SPECIFIC REQUIREMENT'S (Section- Project)
C/ENGG/SPEC/SEC-PROJECT/SPECIFIC REQUIREMENT REV NO 10

Employer has standardized its Specific Requirement for various equipment and works for different voltage levels. Items or clauses, which are not applicable for the scope of this package as per schedule of quantities described in BPS or as per scope defined elsewhere in Section Project, the technical specification/clauses for the items specified below should not be referred to.

S.No.	Clause No.	Amended As (As per Specific Requirement Rev 10)
A.	**Section: GTR Rev 15**	
1.	Clause 2.1 (a)	"All equipment/materials/items, as per **Annexure-K (Rev 01),** as applicable under present scope of works, shall be procured and supplied from domestic manufacturers only with Minimum Local Content for individual items as listed in the above annexure. Any imported equipment/material/item/parts/component (comprising of embedded systems) to be supplied under the contract shall be tested in the certified laboratories to check for any kind of embedded malware/trojans/cyber threats and for adherence to Indian Standards as per the directions issued by Ministry of Power/Govt. of India from time to time. In ca

TYPICAL ARCHITECTURAL DRAWING OF SUBSTATION AUTOMATION SYSTEM (Without Process Bus) for New Substation

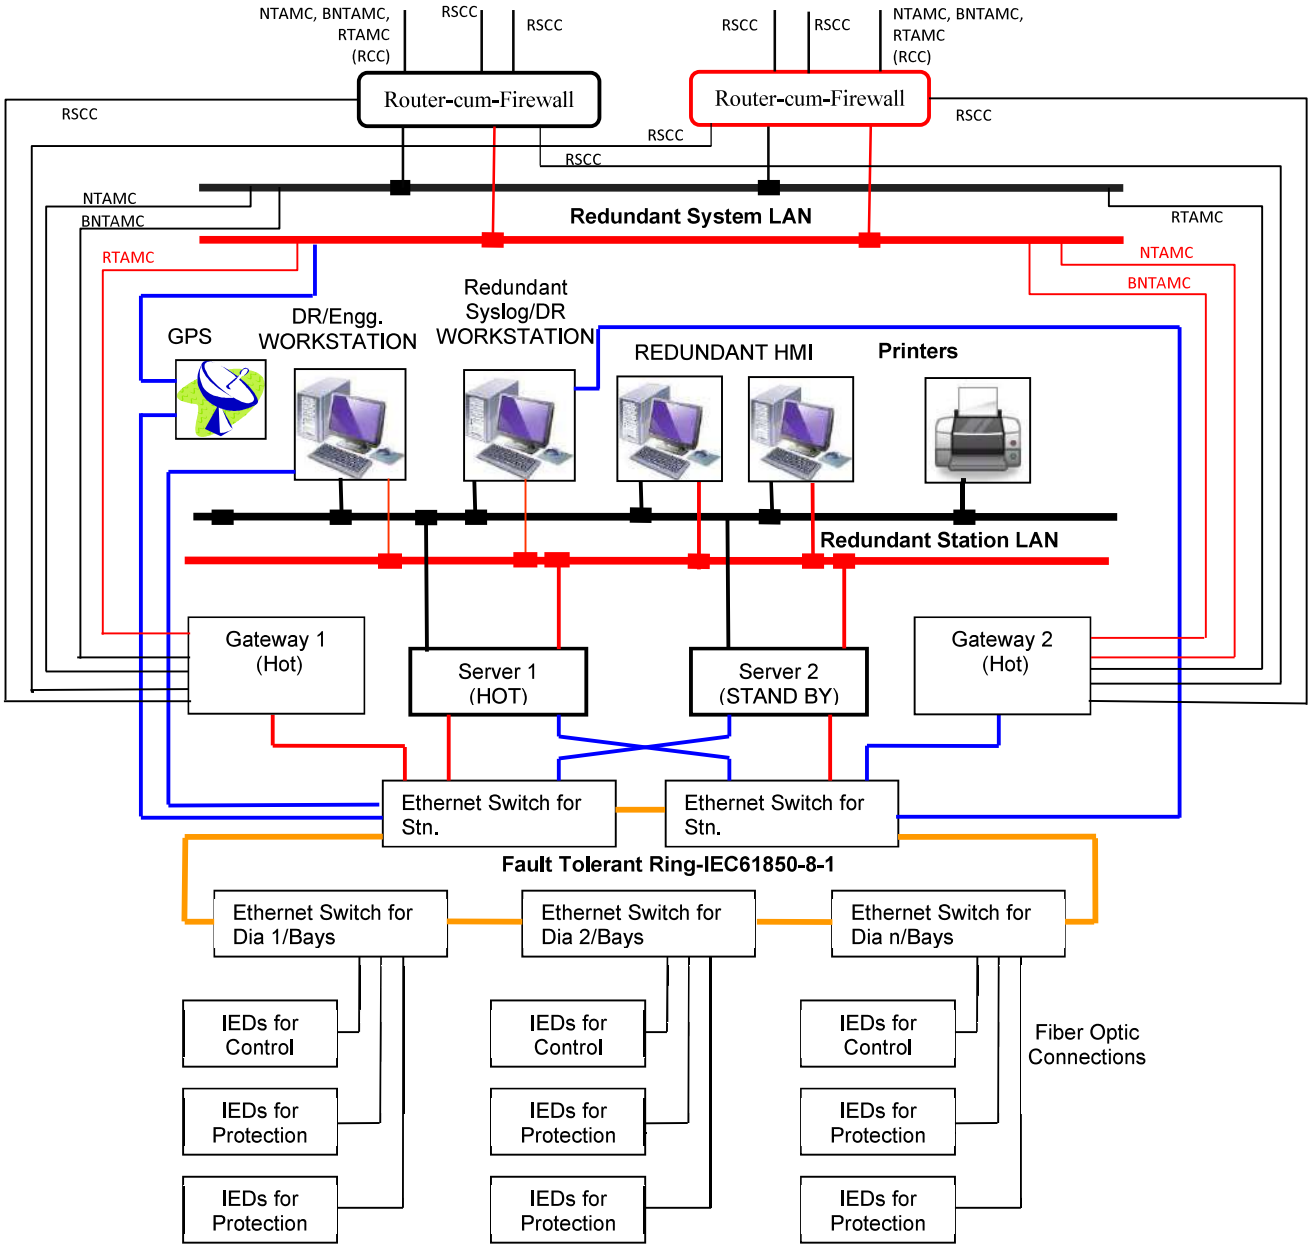
S.No.	Clause No.	Amended As (As per Specific Requirement Rev 10)
L.	**Section SAS Rev 04**	
1.	Typical Architectural Drawing of SAS (Without Process Bus)	TYPICAL ARCHITECTURAL DRAWING OF SUBSTATION AUTOMATION SYSTEM (Without Process Bus) stands replaced by **Annexure-S5**

S.No.	Clause No.	Amended As (As per Specific Requirement Rev 10)
5.	New Para Added Under Clause No.4.1.5	The bidder shall also provide 2 Nos. managed Ethernet switches with at least 16 copper RJ45 ports on each switch to form managed "Redundant System LAN" for connecting different NTAMC sub-systems devices (SCADA Gateways, VMS, VOIP etc.) as per revised system architecture **(attached as Annexure S5)**. The specification of the switches is enclosed at **Annexure-S6.**

Typical Drawing No, Standard/GIS/GROUNDING/01 for above said grounding recommendation is part of this document.

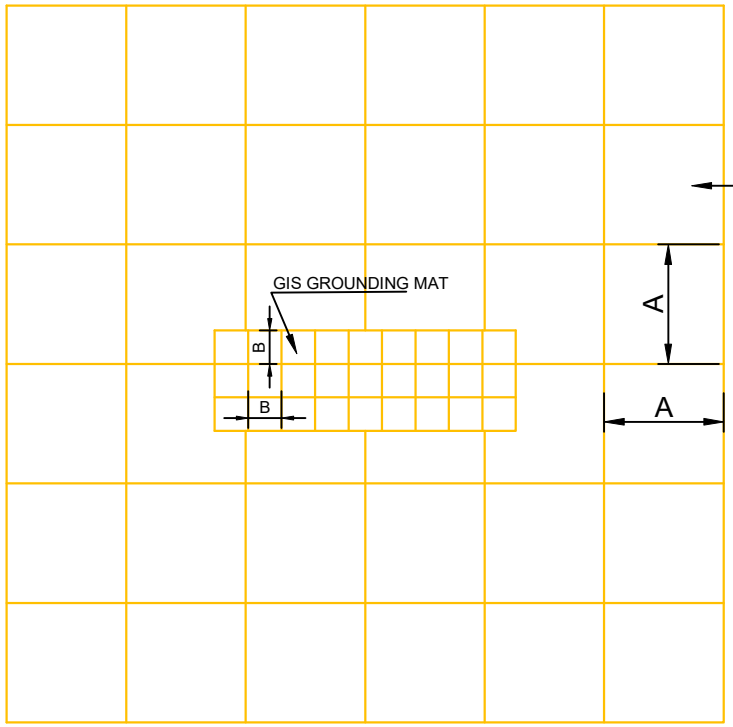
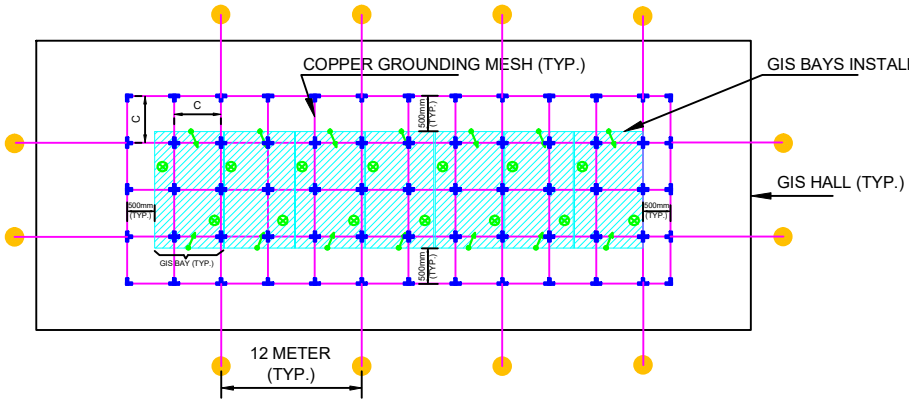
6.	New Clause no. 5.39.8	Reference Guidelines for GIS Grounding shall be as per **Annexure-12 (Attached at Annexure-S10)**
7.	Clause no. 5.40	Adequate number of UHF sensors shall be provided in the offered GIS of voltage level 220kV and above for detection of Partial discharge (of 5pC and above) as per IEC 60270. The number and location of these sensors……..in close proximity to VT compartments. However, adequacy of number of sensors……. to complete the technical requirement. The calibration and frequency response…….couplers meeting this requirement.

1.2. **High Frequency Grounding of GIS equipment**: Dedicated copper grounding mesh with specified spacing and cross-section shall be provided at the top of GIS building finished floor level. This dedicated copper grounding mesh shall be spread-over, beneath complete GIS switchgears installation and extended up to 500 mm away in all direction from GIS switchgears installation. This dedicated copper grounding mesh shall be directly connected to the GIS enclosures (min. at two distant points in each phase/bay) and to the risers directly coming from GIS grounding mat (min. at two distant locations per phase/bay) with the shortest path to the connection point. All Crossing of copper grounding mesh shall be suitably clamped/welded together. Bolted joint at crossings is not allowed, further this copper grounding mesh shall be clamped adequately to the floor at suitable locations. At the jointing of two different metals the joint shall be made using requisite bi-metallic jointer. This dedicated copper grounding mesh is laid at the top of GIS floor and shall also be connected with dedicated grounding rod electrodes provided at a regular interval of not more than 12 meters around periphery of GIS building. This copper grounding mesh shall be laid after the GIS bays are place on the floor and shall be suitably covered with Non-Electrostatic rubber mats to avoid damage to mesh and to avoid hinderance in regular operation of equipment. The Spacing, conductor detail and cross-section of copper grounding mesh shall be as per attached Typical Drawing.
